Ordinance Multi-Use Water Project

ITB-004 Requests for Information (RFI) – Fiberglass Pipe

2/24/23

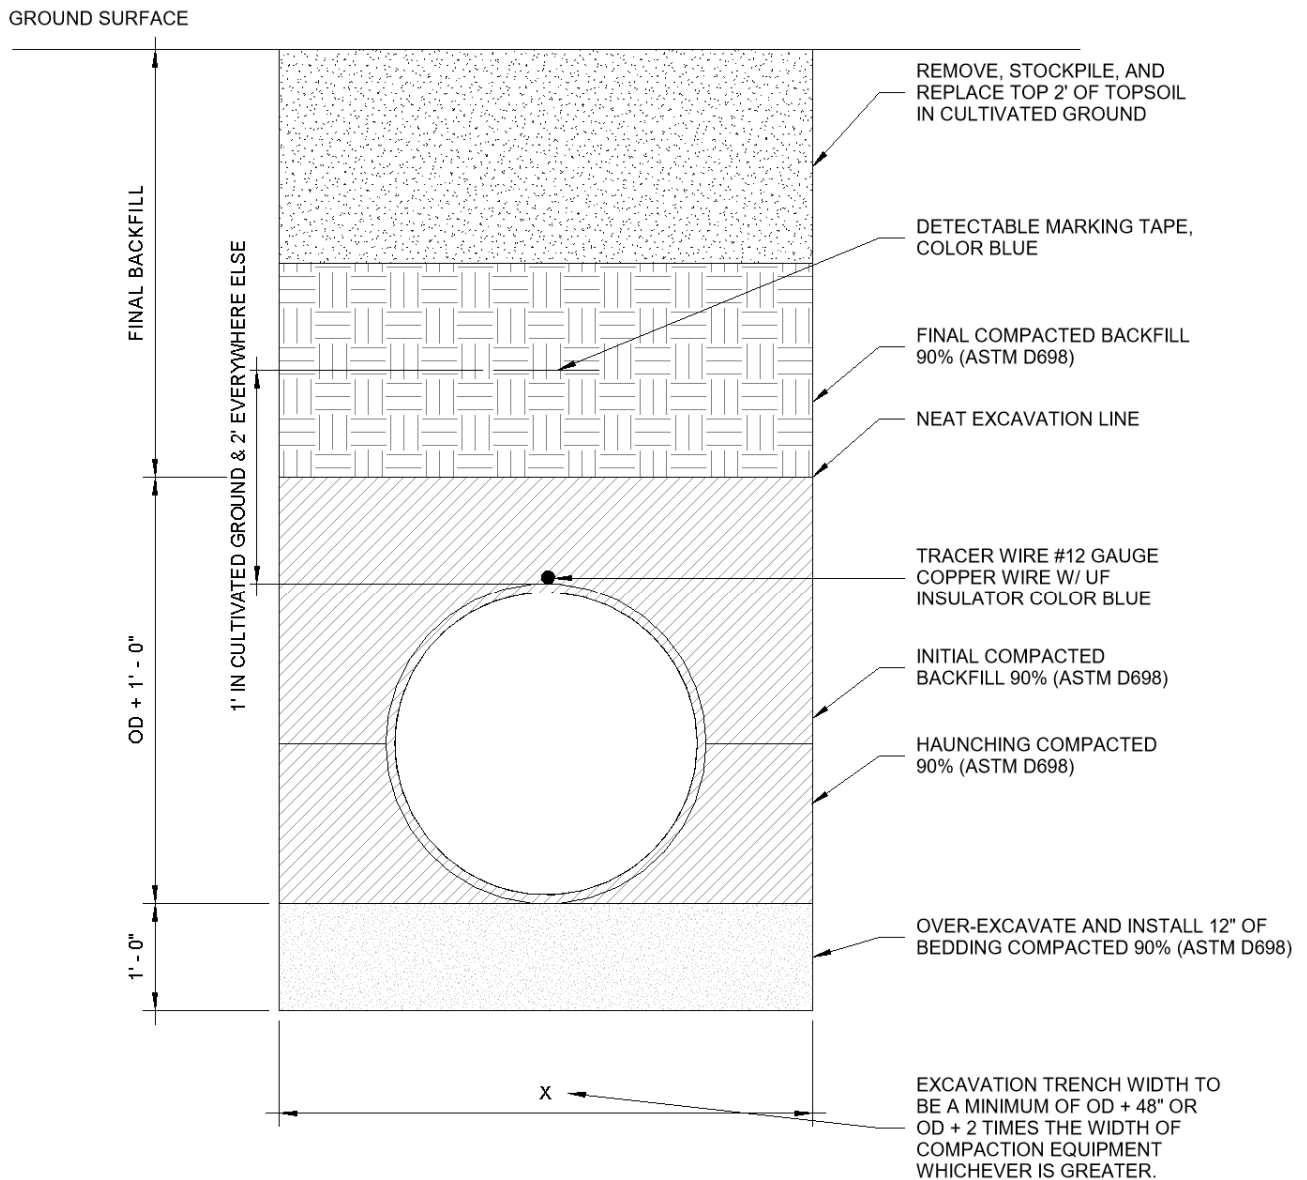
3) RFI #3 – Please provide detail showing trench width and backfill design.

a) RFI #3 Response – See typical trench detail below.
